# UNITED STATES PATENT AND TRADEMARK OFFICE

APPLICATION NO.	FILING DATE	FIRST NAMED INVENTOR	ATTORNEY DOCKET NO.	CONFIRMATION NO.
10/811,092	03/26/2004	Erhard Liebig	5034.1002	9737

<b>Office Action Summary</b>	<b>Application No.</b> 10/811,092	<b>Applicant(s)</b> LIEBIG, ERHARD	
	<b>Examiner</b> William H. Rodriguez	<b>Art Unit</b> 3746

## DETAILED ACTION

Fig. 1

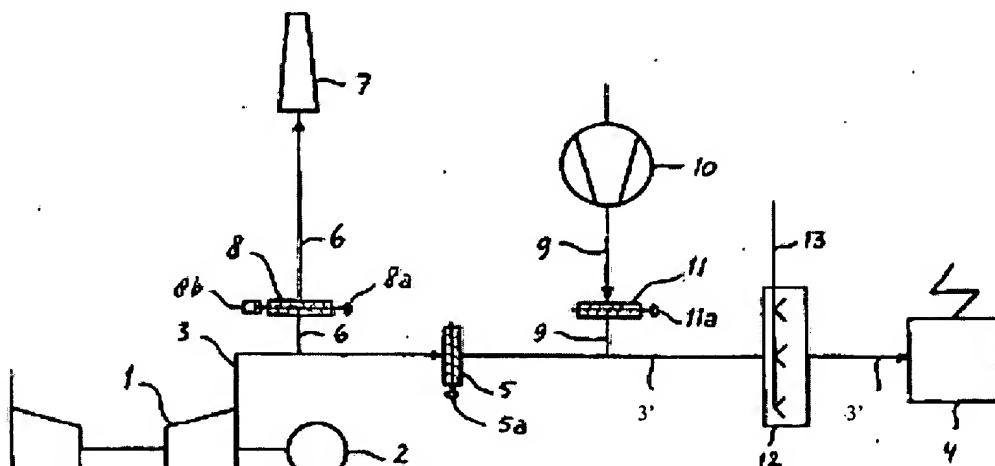
With regards to claims 22 and 23, **Llnnemeyer** teaches an arrangement comprising: a hot-gas generator 1 emitting a mass flow of a hot gas; a technological process 4 disposed downstream of the hot-gas generator; a connector element disposed between the generator and the technological process and configured to feeding a first portion 3' of the mass flow to the technological process; an exhaust 6 including a regulator 8 for discharging a regulated second portion of the mass flow from the connector element and a device 12 configured to influence a temperature of the hot gas disposed between the hot-gas generator 1 and the technological process 4, wherein the hot-gas generator is a combustion engine and the technological process is a steam generator, said influencing includes heating the hot-gas downstream of the hot-gas generator, wherein the heating is performed using an auxiliary combustion, and wherein the auxiliary combustion is performed using said device 12 (burner). See particularly Figure 1 above.

With regards to the method claims 1, 9-15 and 17-21, since **Linnemeyer** has the same structure as claimed, it is inherent that **Linnemeyer's** device would be able to perform the recited method steps. See particularly Figure 1 above.
